Access Compliance Report Public Rights-of-Way (Curb Ramps)

Main Street: DRUID_LN Cross Street: SILVER_FOX_RD Location: SE

ADA ID: RPRK211206171305 Ramp Type: Type 1 - Perpendicular Diagonal Initial Pass/Fail: Fail Overall Compliance: No Severity Score: 16

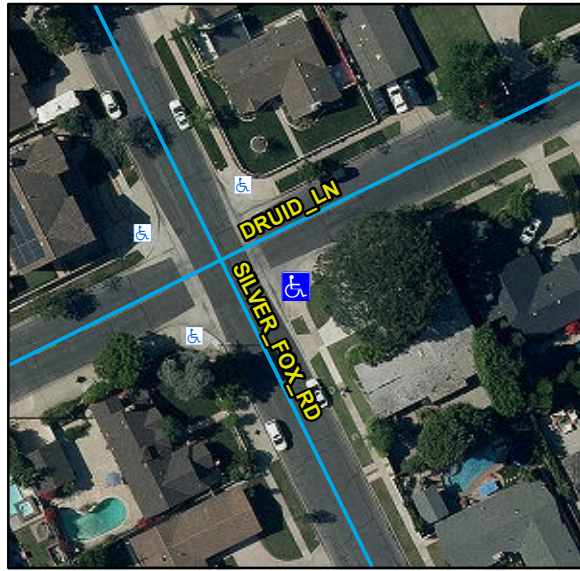
Compliance	Description	Data	Compliance	Description	Data
N/A	Ramp Length (in)	132	N/A	Flare Type LT	
Yes	Ramp Width (in)	48			N/A
No	Ramp Run Slope (%)	9	N/A	Flare Slope LT (%)	N/A
No	Ramp Cross Slope (%)	2.1	N/A	Flare Traversable LT	N/A
N/A	Landing Present	N/A	N/A	Flare Type RT	
N/A	Landing Length (in)	N/A			N/A
N/A	Landing Width (in)	N/A	N/A	Flare Slope RT (%)	N/A
N/A	Landing Run Slope (%)	N/A	N/A	Flare Traversable RT	N/A
N/A	Landing Cross Slope (%)	N/A	N/A	DWS Provided	N/A
N/A	Landing Movement Obstructed?	N/A	N/A	DWS Contrast	N/A
	Landing Movement Type	N/A	N/A	DWS Length (in)	N/A
N/A	Landing Shared	N/A	N/A	DWS Full Width	N/A
N/A	Clear Space	Yes	N/A	DWS Offset Left (in)	N/A
N/A	Clear Space To Crosswalk (in)	N/A	N/A	DWS Offset Right (in)	N/A
N/A	Marked Crosswalk 1	No	N/A	Marked Crosswalk 2	No
	Crossing 1 Direction	N		Crossing 2 Direction	W
	Marked Crosswalk 1 Width (in)	N/A		Marked Crosswalk 2 Width (in)	N/A

N/A	Ramp Inside Crosswalk 1	N/A	Yes	Ramp Inside Crosswalk 2	N/A
	Crossing 1 Slope (%)	5		Crossing 2 Slope (%)	7.8
	Crossing 1 Cross Slope (%)	0.1		Crossing 2 Cross Slope (%)	1.5
N/A	Gutter Ponding	N/A	No	Curb Slope	5.5
No	Gutter Lip Height (in)	0.5		Road Run Slope (%)	1.2
N/A	Gutter Run Slope (%)	N/A		Road Cross Slope (%)	3.2
N/A	Gutter Cross Slope (%)	N/A			
Yes	Overall Surface Condition: Acceptable		No	Perp Joint Present	No
	Cross Gutter Present?	Yes		Spandrel Present?	Yes
	Replace Cross Gutter?	No		Replace Spandrel?	No

Remove & Replace Curb Ramp With Two New Directional Ramps or Equivalent.
